**Addendum No. 2**  
**November 17, 2021**

Project: Corsica-Stickney H.S. Addition  
Corsica, South Dakota  
Architect's Project No.: 2910

Architect: Architecture Incorporated

5.40

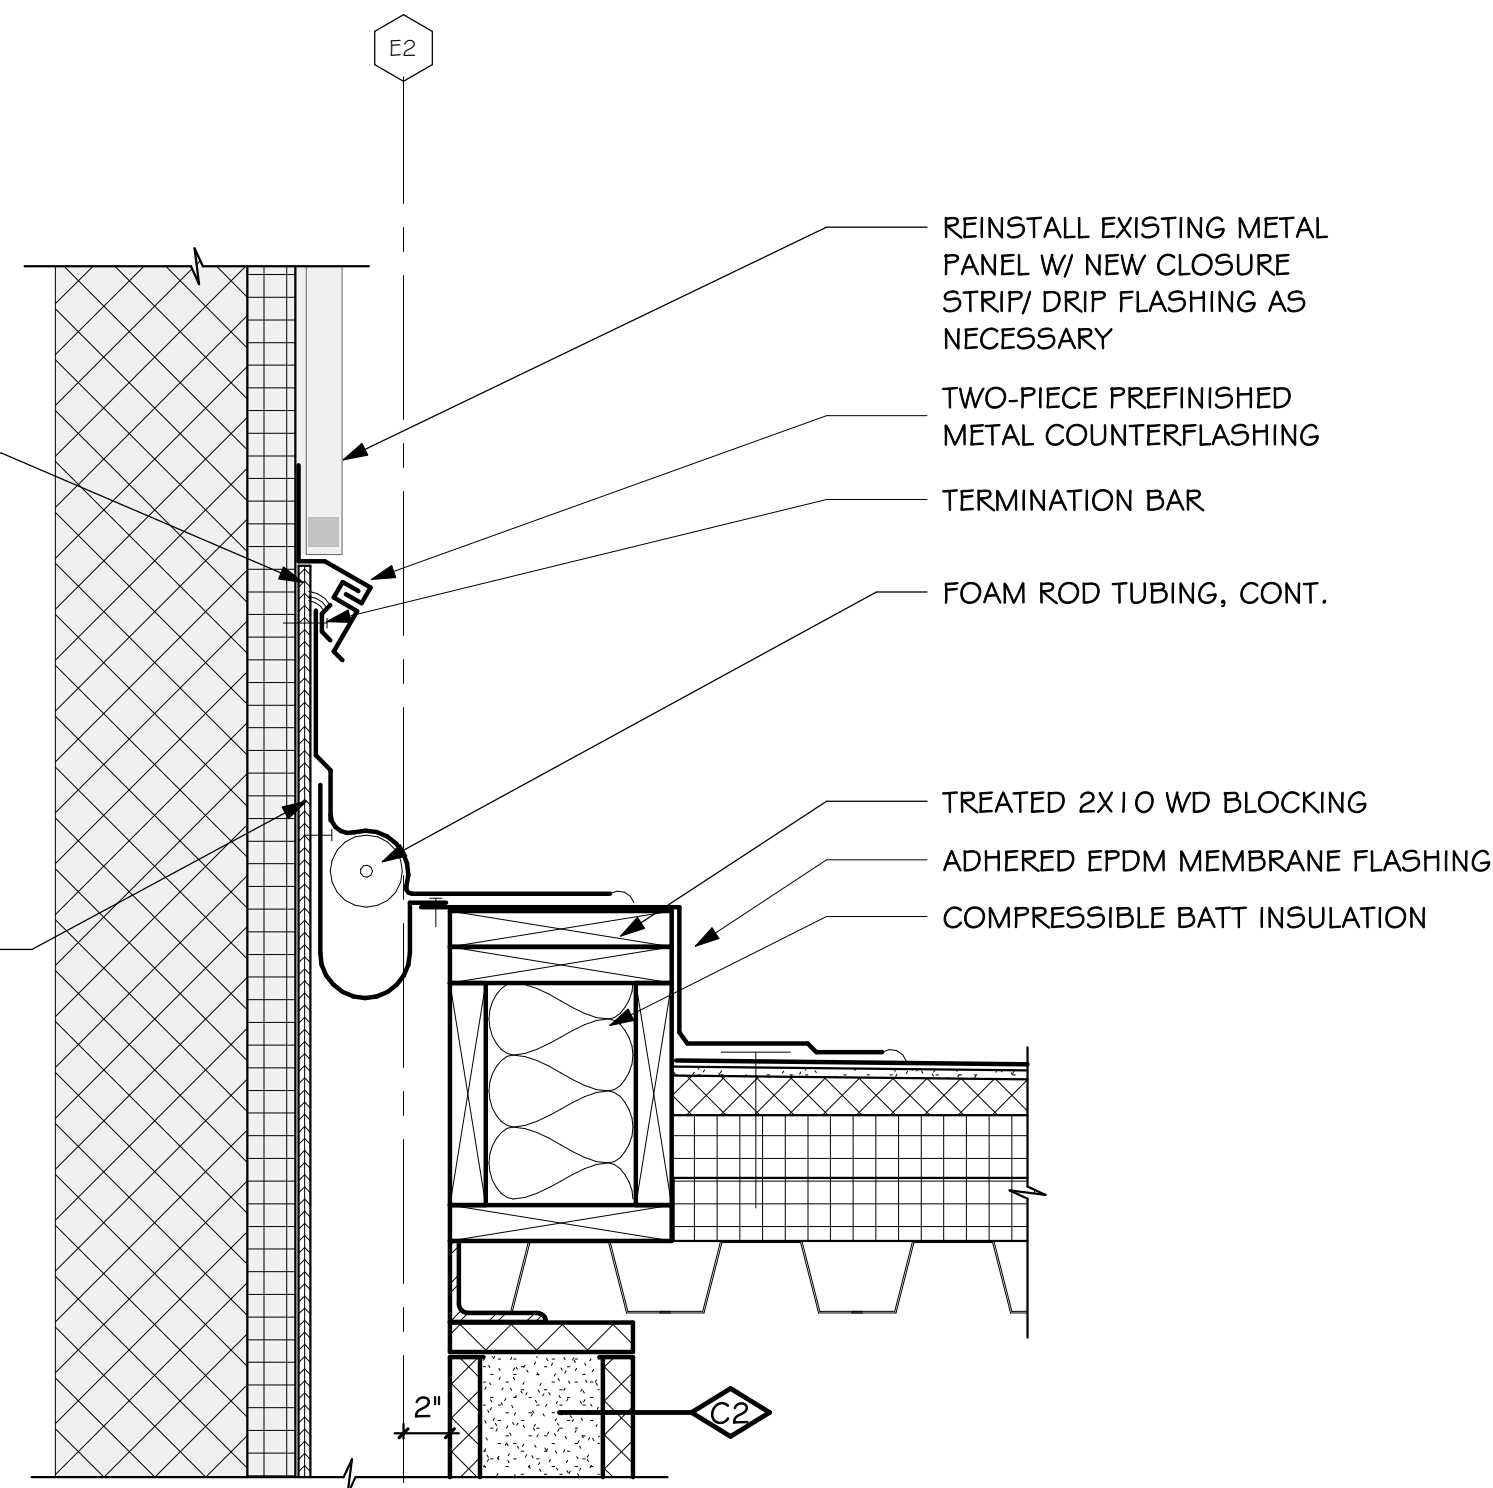
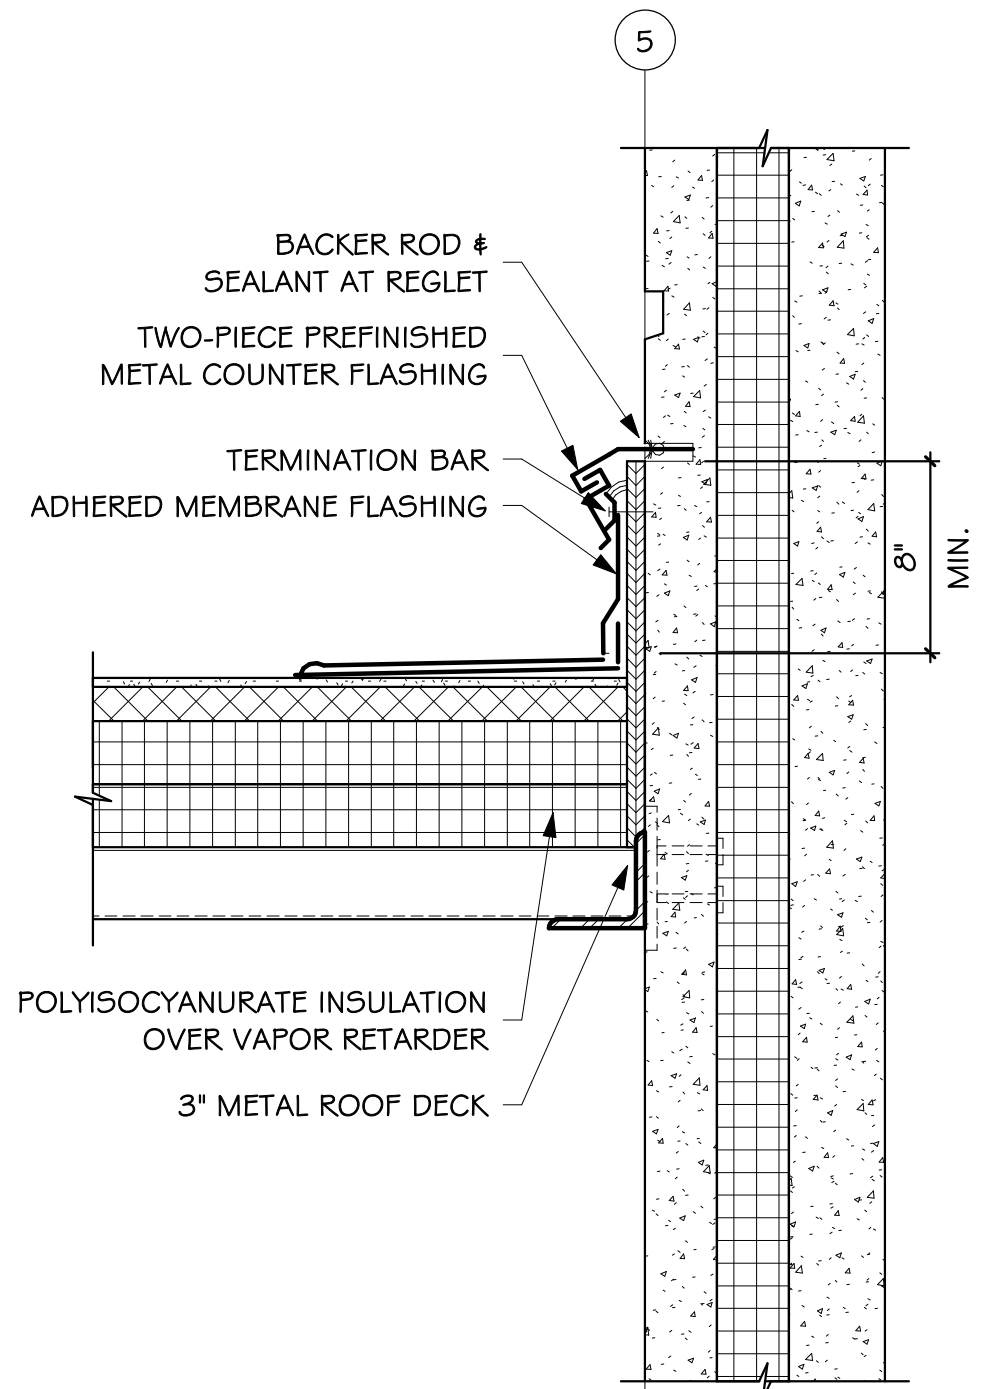
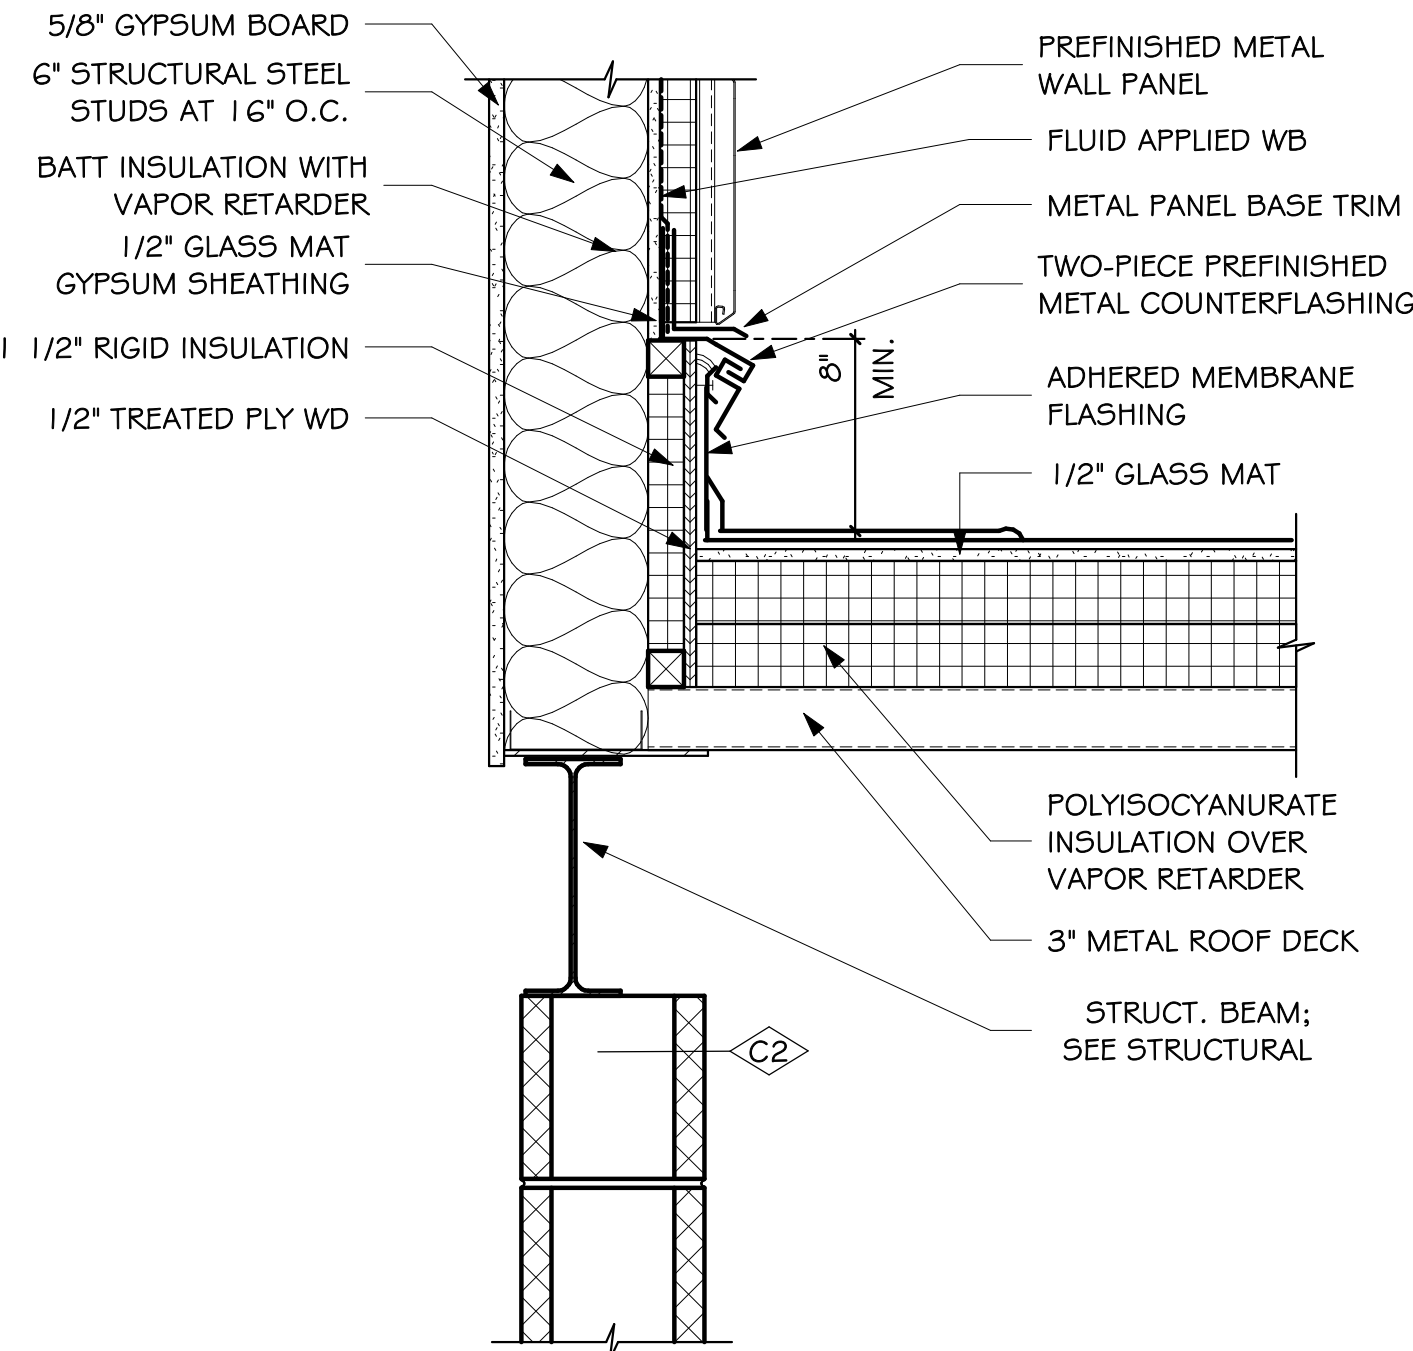
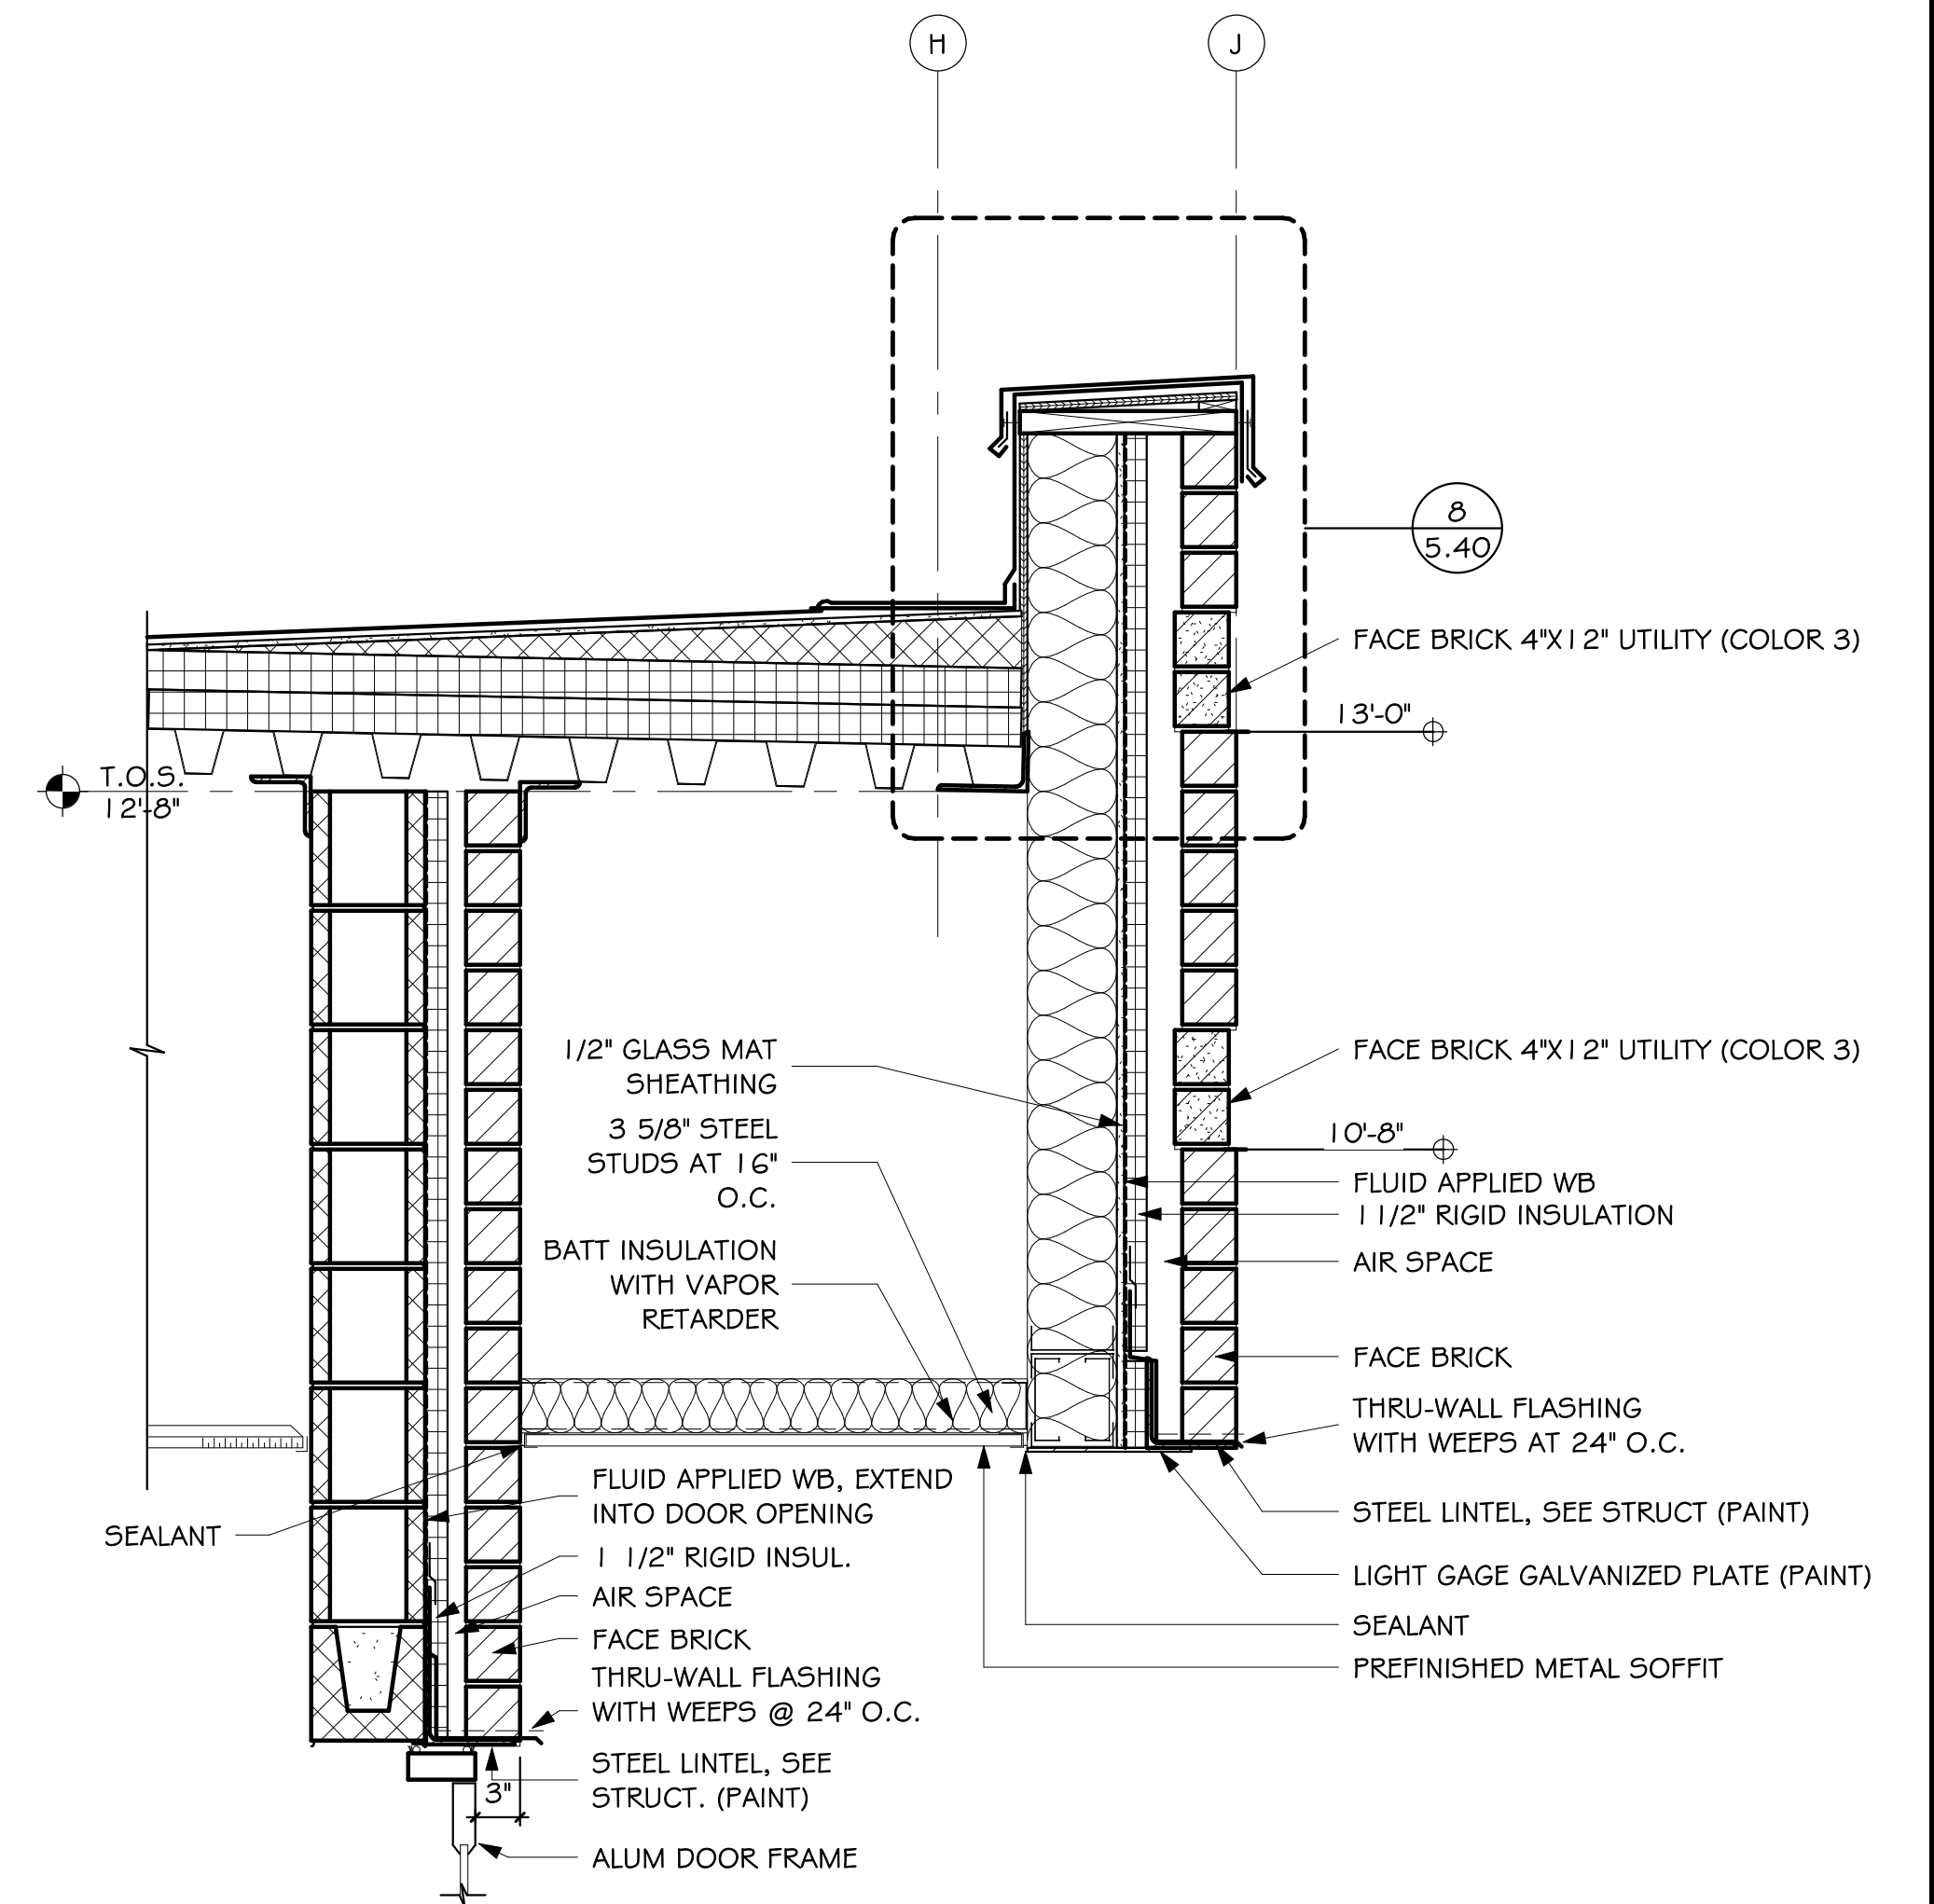
- a) **MODIFY** Storefront SF3, SF4, SF5 and SF 6 to 11’-0” in height
  - b) **MODIFY** Details 16/5.11 and 23/5.11
- 10) **SHEET 5.40 SECTION DETAILS:** See new sheet clouded and tagged with “2”

- a) **MODIFY** Detail 9/5.40
- 11) **SHEET 5.41 SECTION DETAILS:** See new sheet clouded and tagged with “2”
  - a) **MODIFY** Detail 6/5.40
